Access Compliance Report

Public Rights-of-Way

(Curb Ramps)

| Intersection ID: 11900 | Main Street: CLARKSON_GREEN_ST | Cross Street: GREENLEAF_AV | Location: S |

| ADA ID: 7FA90528E8F1 | Ramp Type: Perp | Initial Pass/Fail: Fail | Overall Compliance: No |

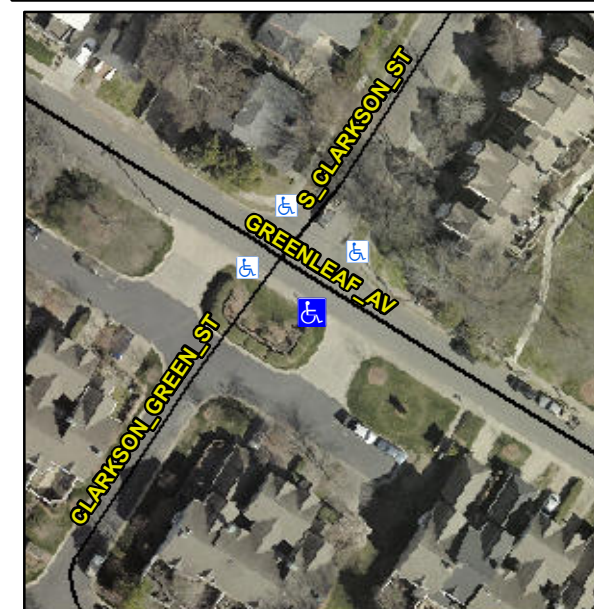
R304.5.1, R304.2.2, R304.5.3

| Compliance | Description | Data | Compliance | Description | Data |
|------------|-----------------------|-------|------------|-----------------------------|------|
| N/A | Ramp Length (in) | 48.0 | No | Ramp Slope (%) | 10.9 |
| No | Ramp Width (in) | 40.0 | No | Ramp XSlope (%) | 3.3 |

Remove & Replace Entire Ramp.
